Draft Final Decision Document
for the Sanitary Sewer System
Interim Response Action
at Rocky Mountain Arsenal

March 1989

COMMENTS ON THE PROPOSED DECISION DOCUMENT
FOR THE SANITARY SEWER SYSTEM INTERIM RESPONSE ACTION
JANUARY 1989

RESPONSE TO US EPA REVIEW COMMENTS ON
THE PROPOSED DECISION DOCUMENT FOR THE
SANITARY SEWER SYSTEM INTERIM RESPONSE ACTION
AT ROCKY MOUNTAIN ARSENAL

Figure 3.
 Sanitary Sewer in South Plants

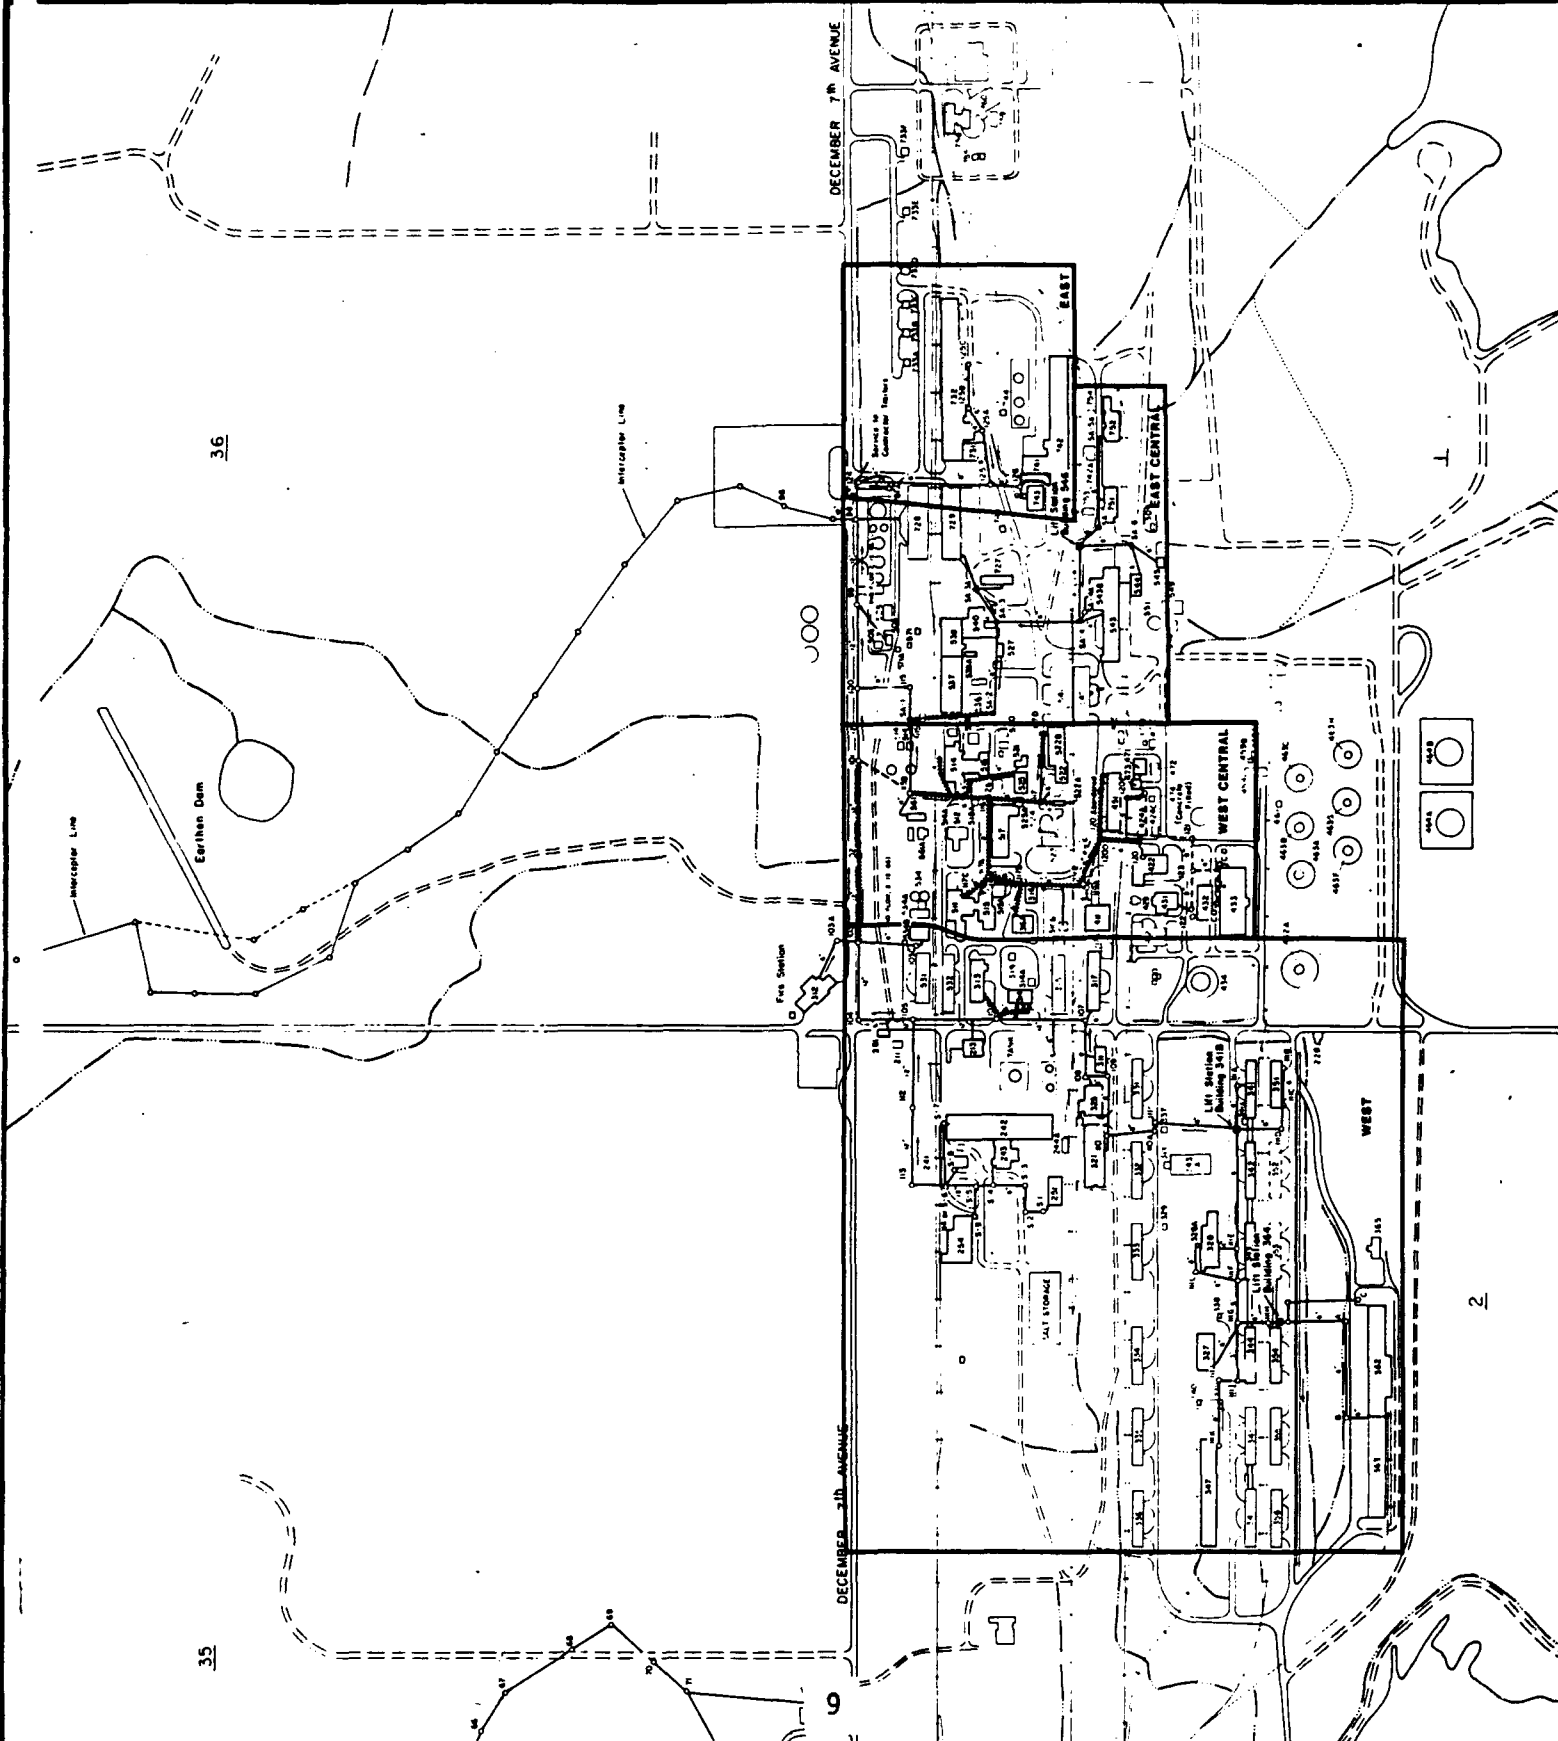
3. Page 8, first paragraph under 4.2, second sentence. The statement is made that "actions are currently being taken to limit activities" in the South Plants. However, it is apparent from the discussion in the following four paragraphs that the decisions on which buildings to close, relocate, etc., have yet to be made.

4. Page 8, second paragraph under 4.2. The Shell trailer should be added to the list of buildings serviced by the sanitary sewer.

5. Page 8, third paragraph under 4.2. Building 316A should be added to the list of active buildings connected to the central boiler house.

Response: Yes, these decisions have been made. The text has been revised to reflect the Army's position.

Response: Referenced text has been deleted as part of the revisions made in response to Comment 3.

Response: Referenced text has been deleted as part of the revisions made in response to Comment 3.
